Car Stereo
Service Bulletin

Model: CDX-R88 **No.** 98

Subject: Amp Remote Out Fails To Turn On Power Amps **Date:** May 9, 1988

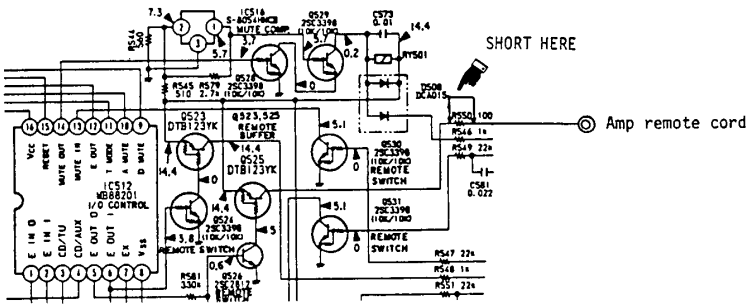
The amp remote output cannot turn on a number of amplifiers connected in parallel. The maximum current available at this output is 35mA. The input current to other manufacturer's amplifiers may be more than 10mA per unit.

Jumper across R550 (100 ohms) on the main board as shown.
